APPROVED TO PROCEED SUBJECT TO SPECIAL INSPECTION REPORT 8/5/2022 DL

Re: Foundation Assessment and Repair Recommendations for the Ross Family Residence at 110 9th Street SW in Puyallup, Washington

PRRRSF20221108

Project: FOUNDATION STABILIZATION @ 110 9th St SW

FOUNDATION STABILIZATION
FOR ROSS @ 110 9th St. SW, PUYALLUP

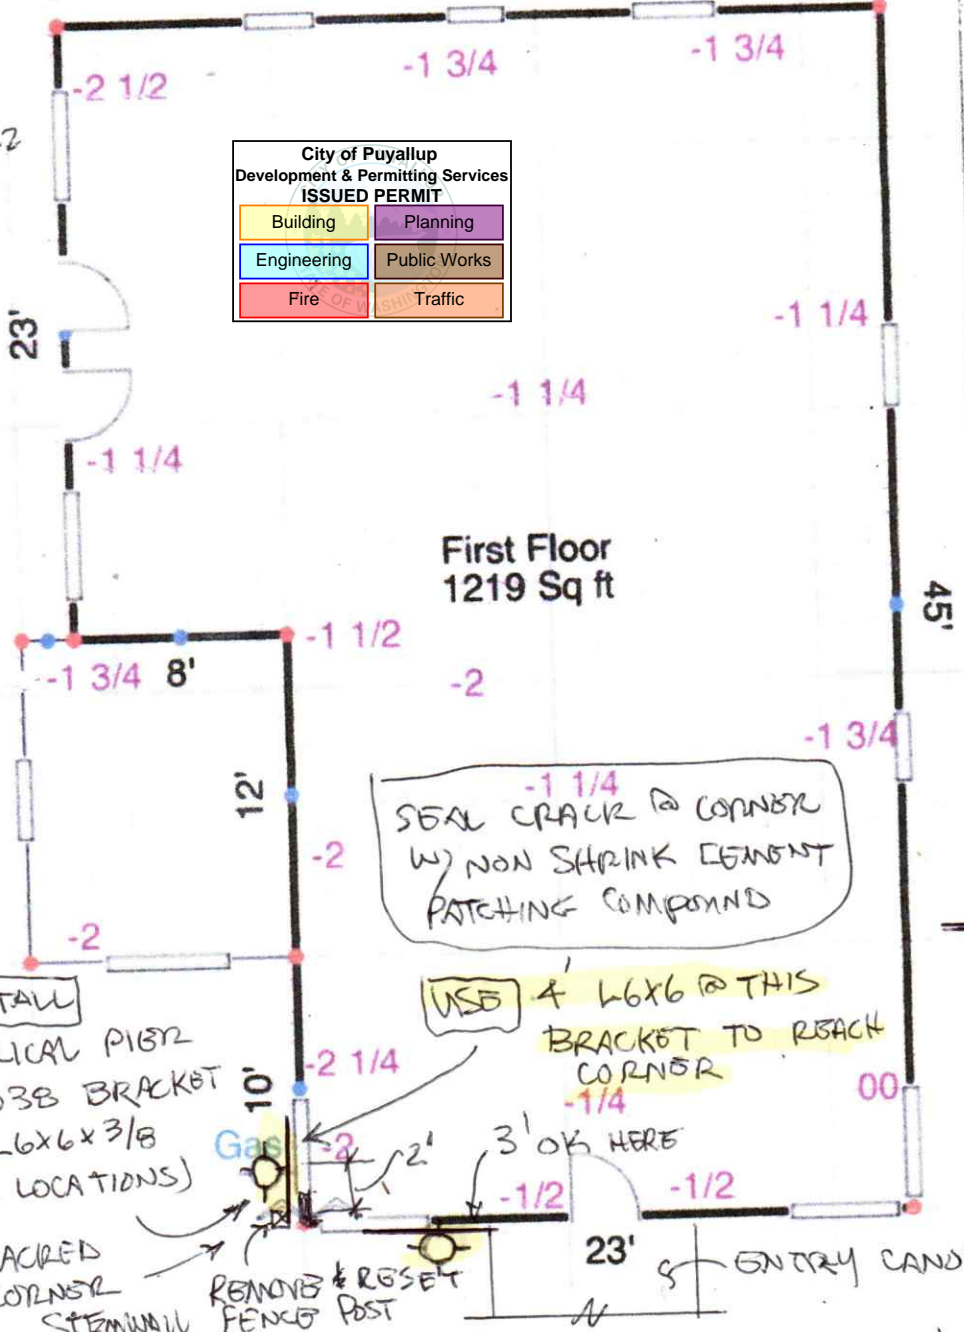
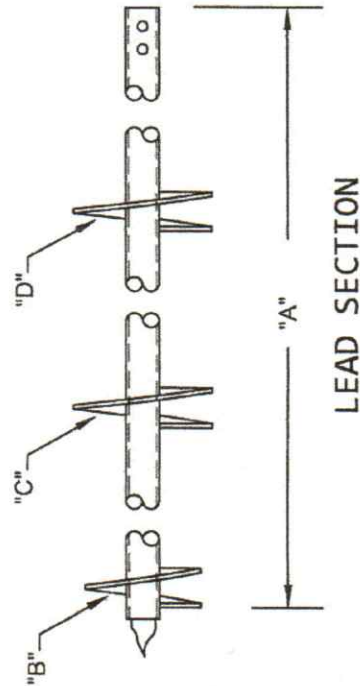
ENGINEER OF RECORD TO PROVIDE CONTINUOUS SPECIAL INSPECTION PER THE ESR REPORT PER APPLICANT. THEN PROVIDE CITY INSPECTOR REPORT AND FINAL LETTER AT TIME OF FINAL INSPECTION.
